Special Use Permit #2012-0078
3401 Mount Vernon Avenue – Taco Restaurant

Application	General Data	
Consideration of a request to operate a restaurant with a parking reduction.	Planning Commission Hearing:	January 3, 2013
	City Council Hearing:	January 12, 2013
Address: 3401 Mount Vernon Avenue	Zone:	CSL / Commercial Service Low
Applicant: Jose Mario Cabero and Jose Guillermo Cabero by Mabel Tweddle, agent	Small Area Plan:	Potomac West

Staff Reviewers: Nathan Randall nathan.randall@alexandriava.gov

PROPOSED SITE PLAN
 Parking Layout

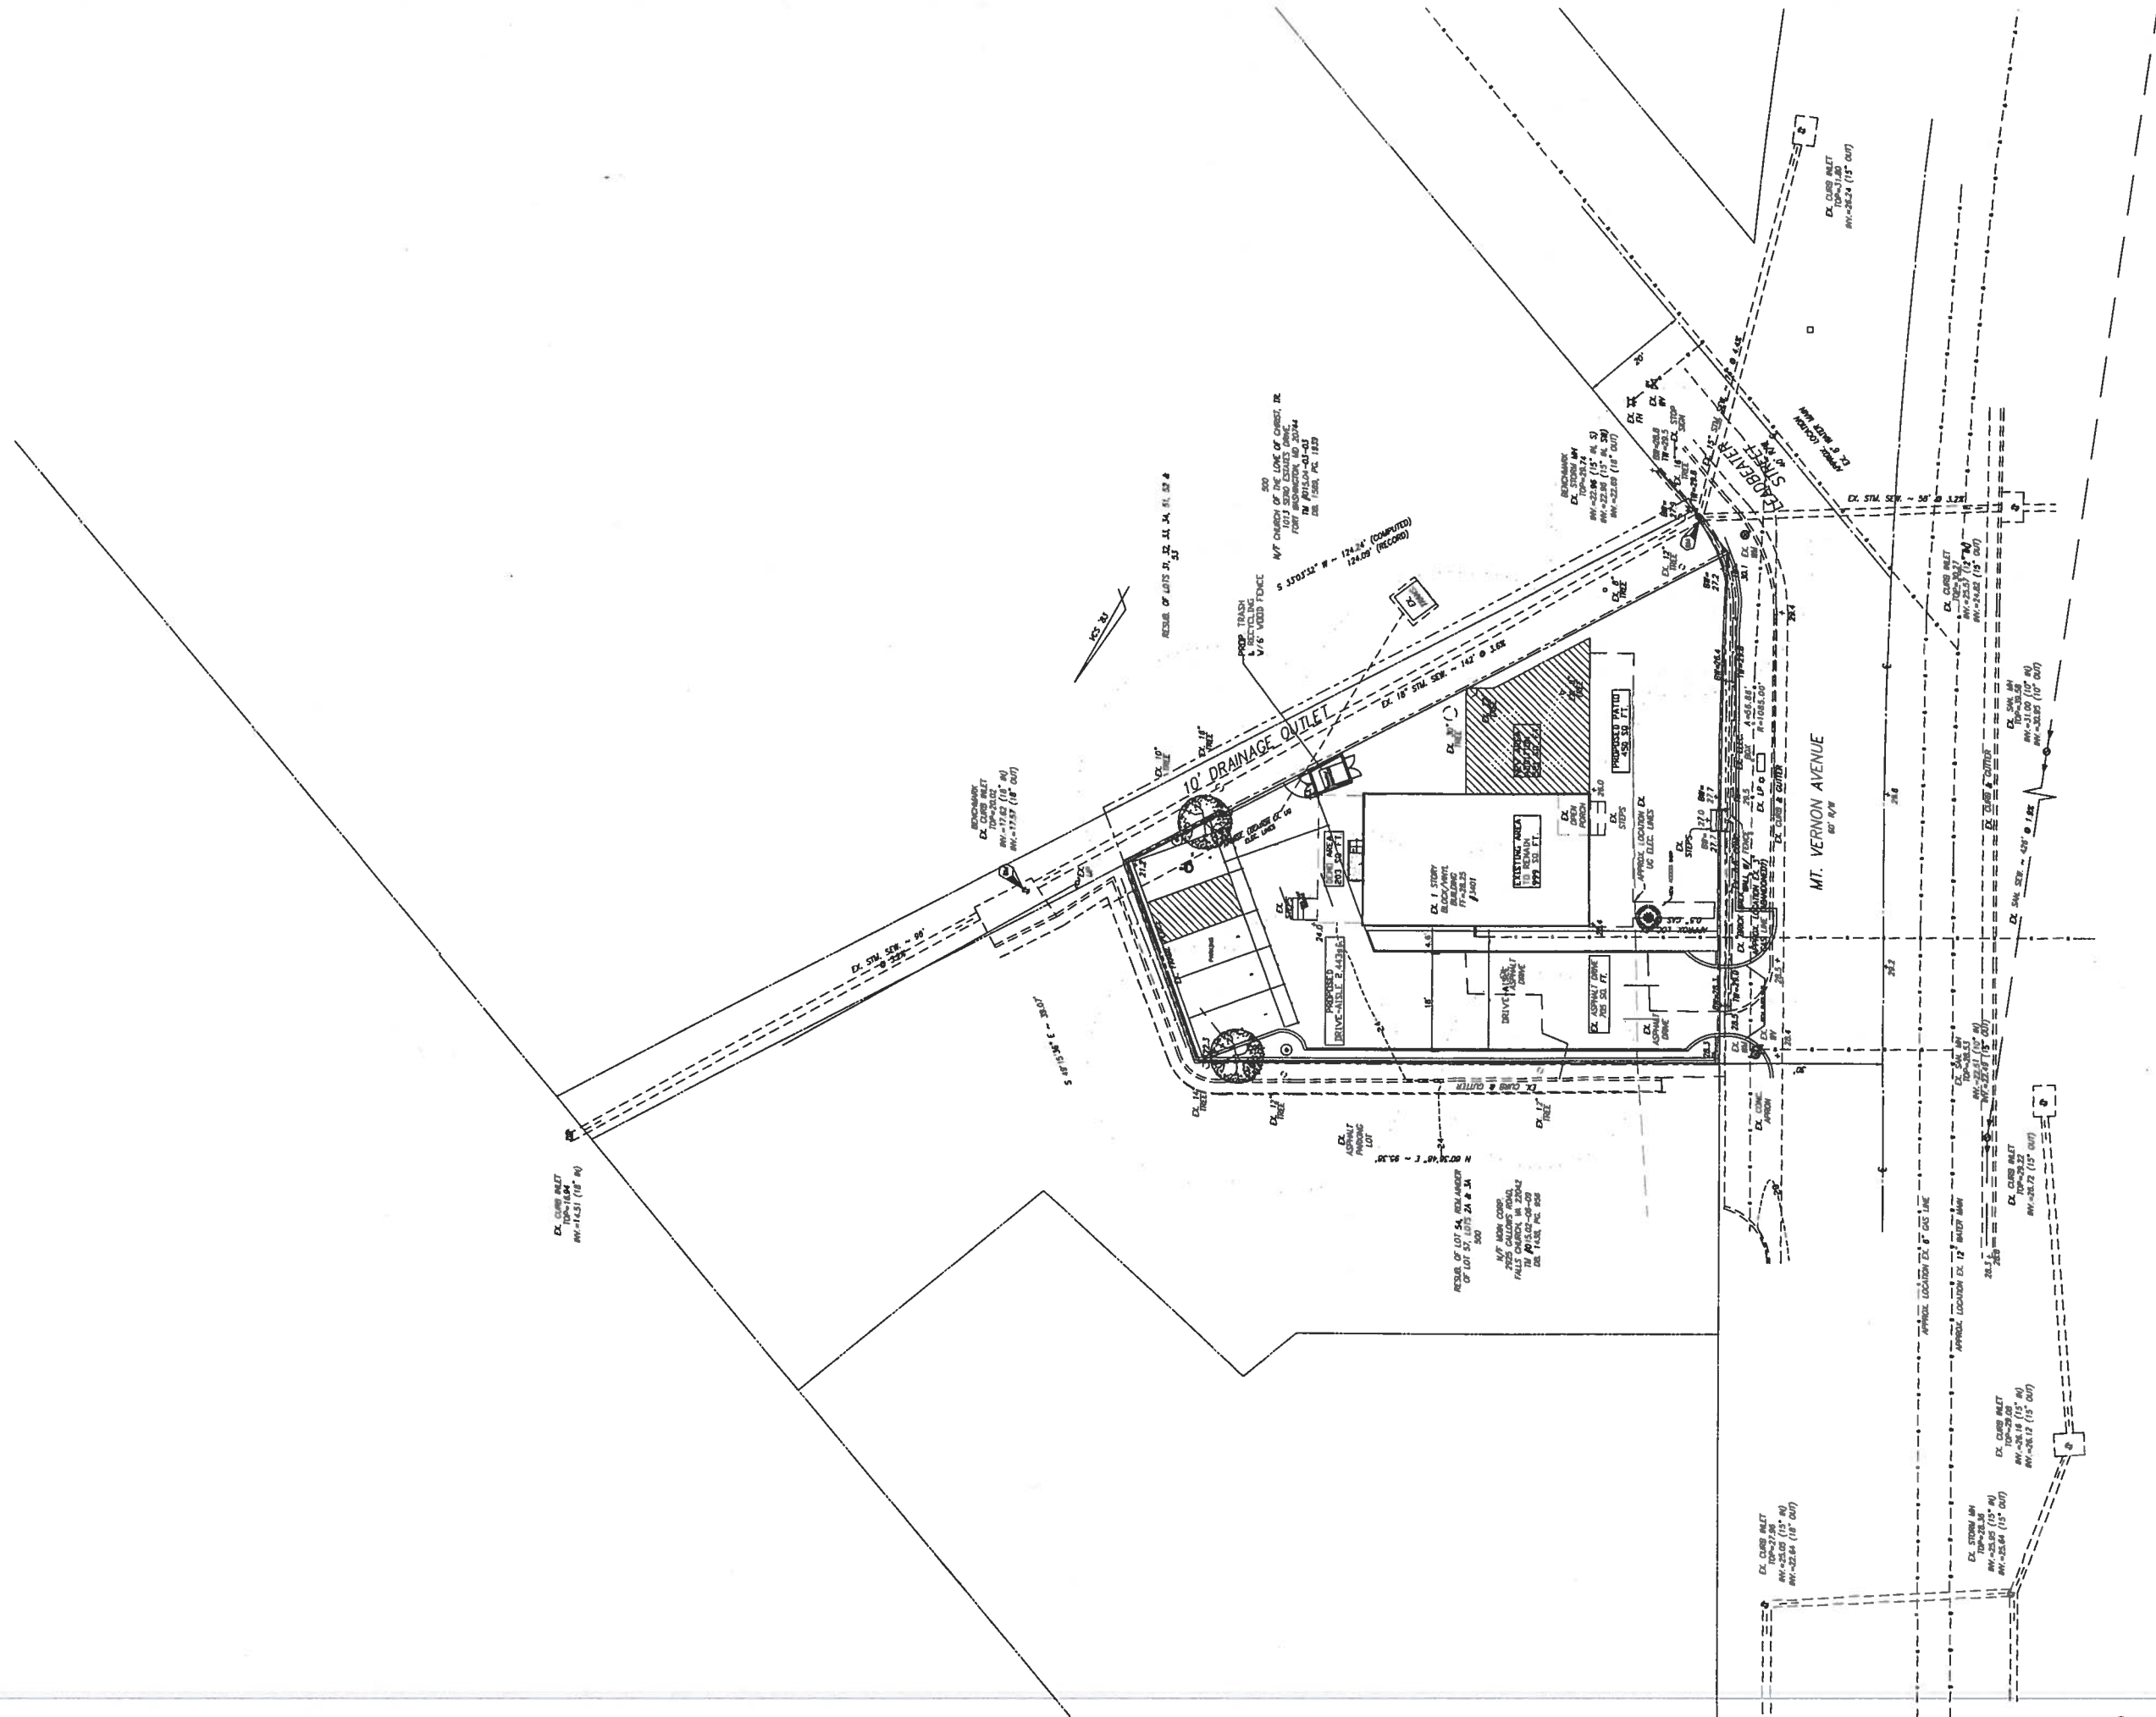
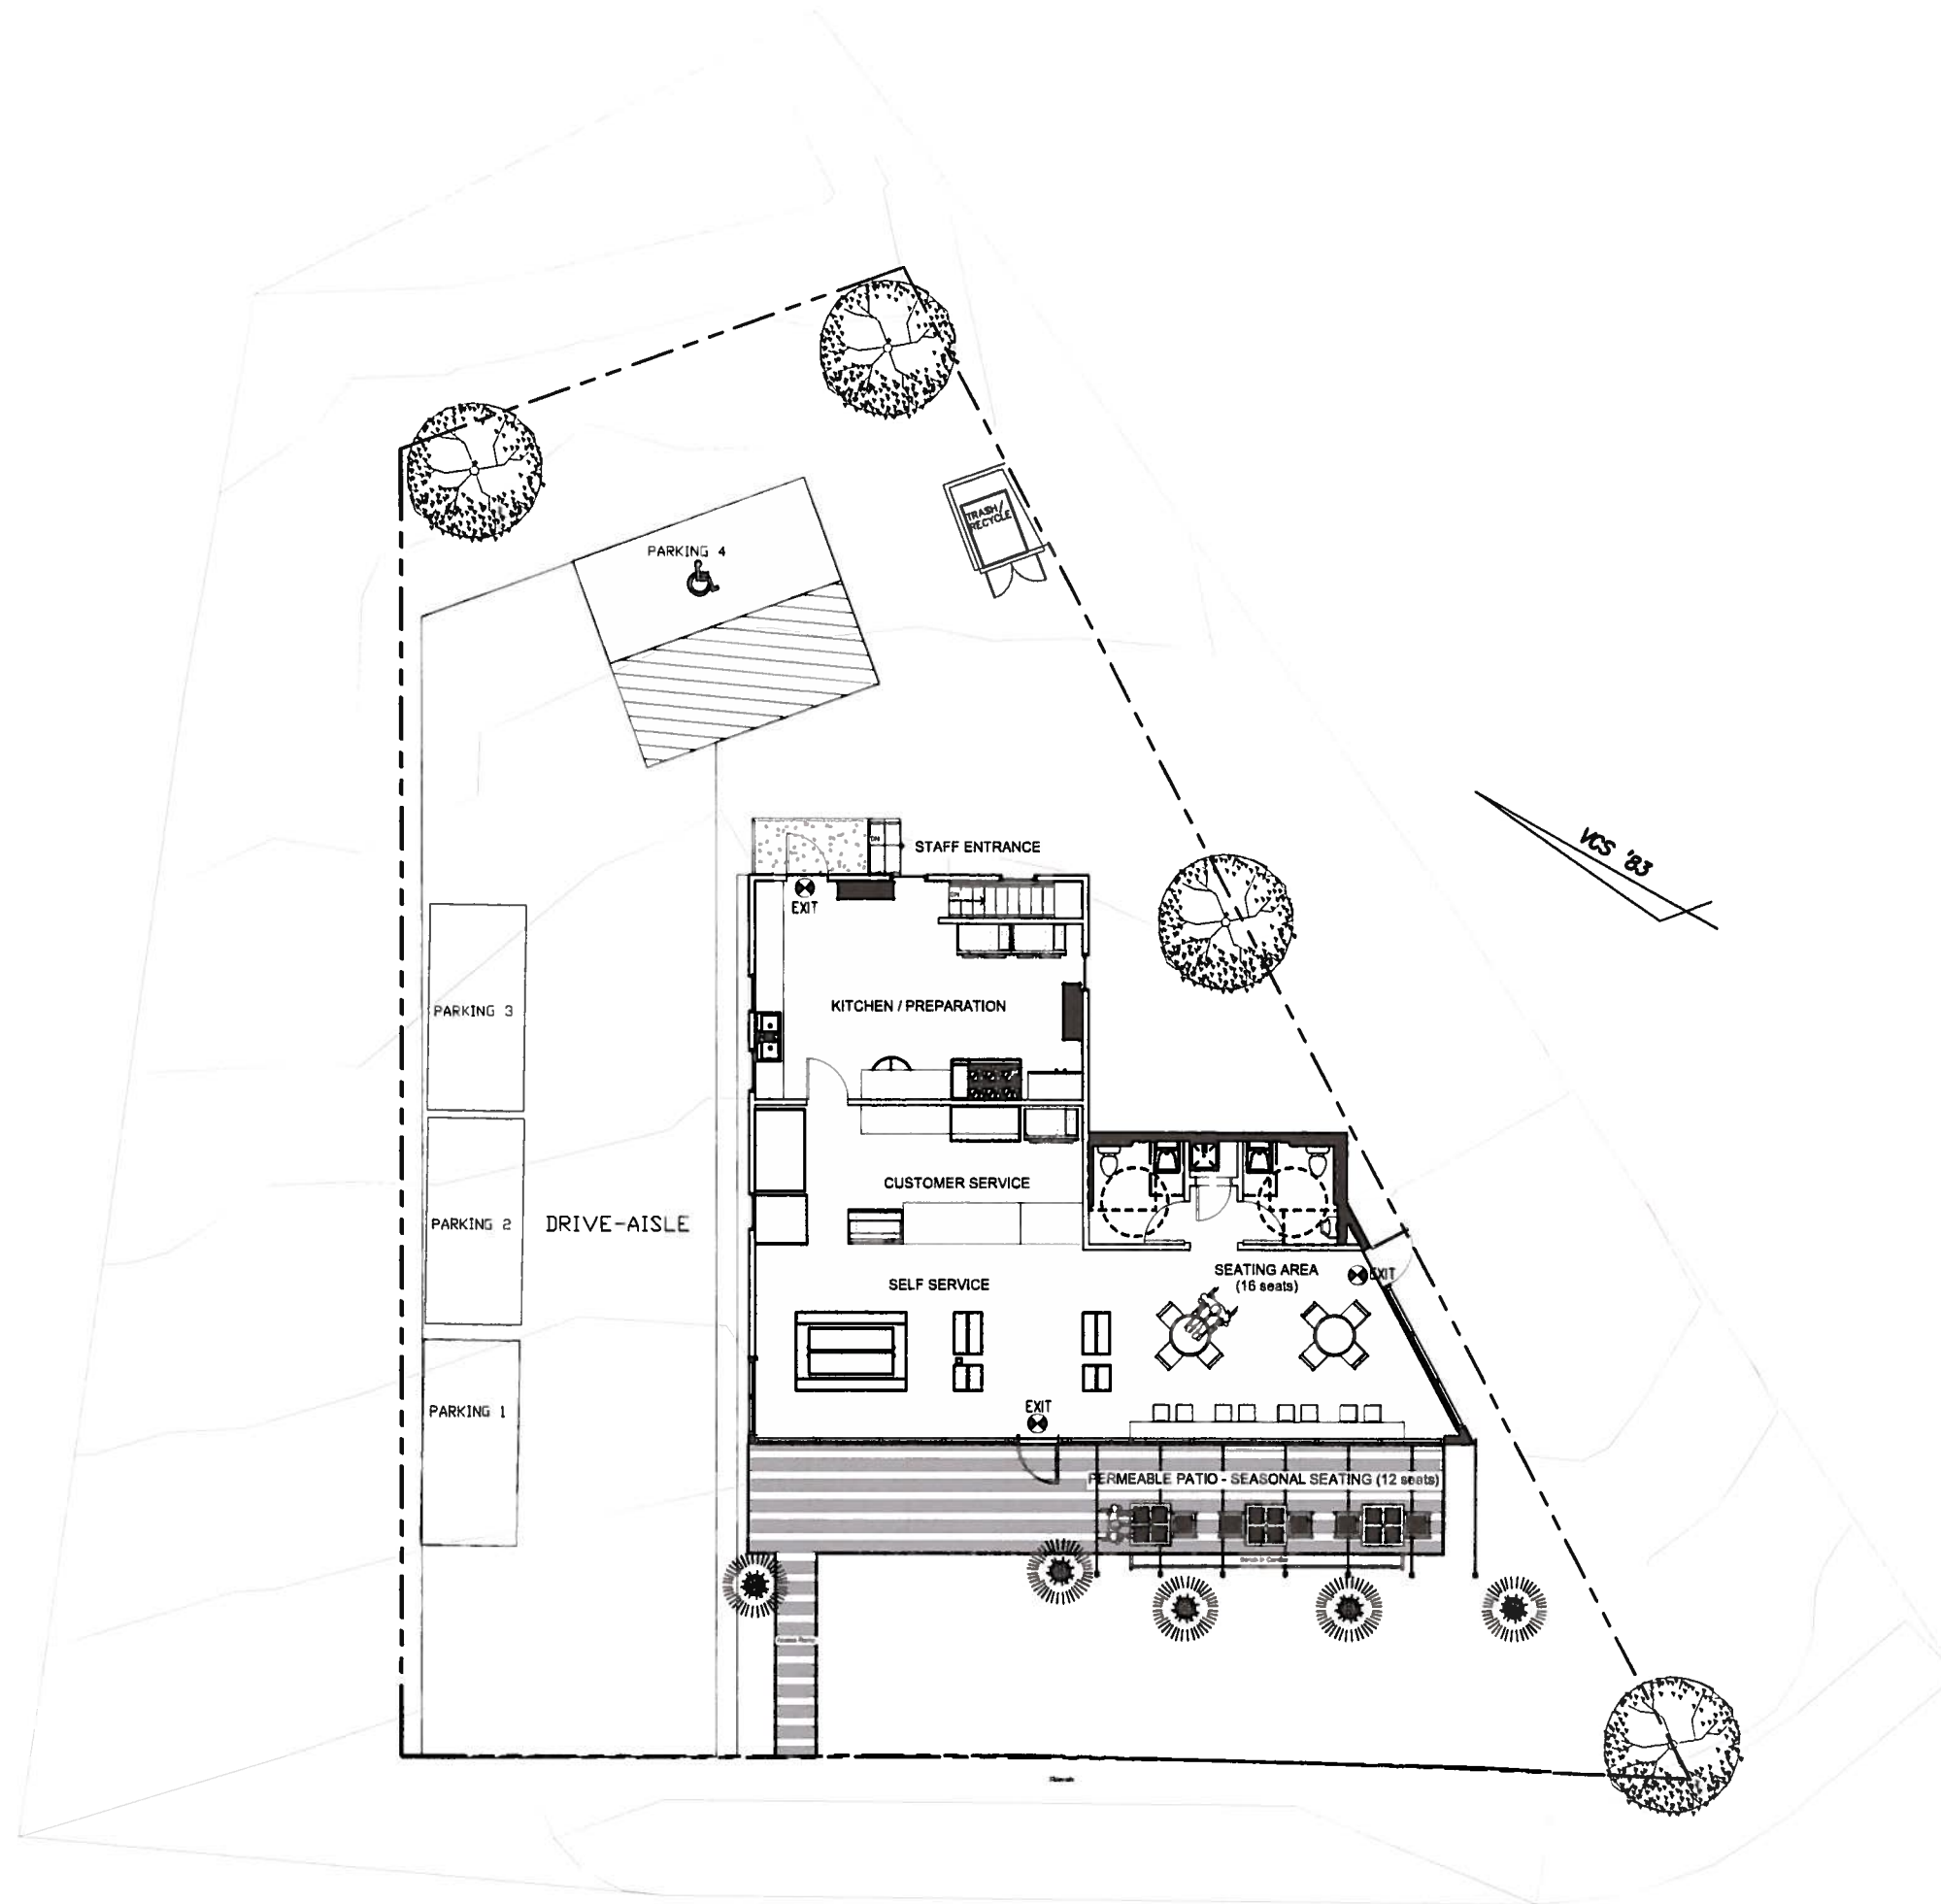
- F-1 Due to site limitations, the applicant has proposed a parking lot area that does not meet certain zoning ordinance requirements:
- a. The width of the spaces will not meet zoning ordinance requirements
 - b. The drive aisle width from Mt. Vernon Avenue to the rear parking area is below zoning ordinance requirements.
 - c. The driveway entrance is narrowed to below zoning ordinance requirements.

Despite not meeting the technical zoning ordinance requirements, T&ES supports the proposed parking layout. There are several reasons for this support:

- The size of the lot, specifically the lot width, limits the ability to create parking space widths that meet zoning ordinance requirements. The required ADA parking space requires a minimum 8' wide space with a minimum 8' wide access aisle, which therefore requires each of the non-ADA spaces to be approximately 6 inches narrower than required by the zoning ordinance in order to fit within the lot boundary.

- The 18' drive aisle between Mt. Vernon Avenue and the parking area is consistent with an 18' shared drive aisle for two businesses across the street that have a similar rear parking area behind the building. Using an 18' drive aisle instead of the 20' drive aisle allows for a wider green space buffer between the drive aisle and the building. The low speed and low volume nature of the drive aisle also lends support to an 18' wide drive aisle.

- The driveway entrance is shared with the adjacent parcel (currently a JiffyLube), thereby creating a very wide curb cut. T&ES supports narrowing the curb cut on the applicant's property from 18' to 12'. This will reduce the overall width of the shared curb cut from approximately 42' to 36', thereby improving the pedestrian experience for pedestrians on Mt. Vernon Avenue. The reduction in curb cut width also minimizes the impact to an existing retaining wall and will minimize the grading required on the property.

- When compared to the originally submitted parking layout configuration, the presently proposed layout now allows all parked vehicles to turn around on site; no vehicles will have to back out onto Mt. Vernon Avenue from the driveway.
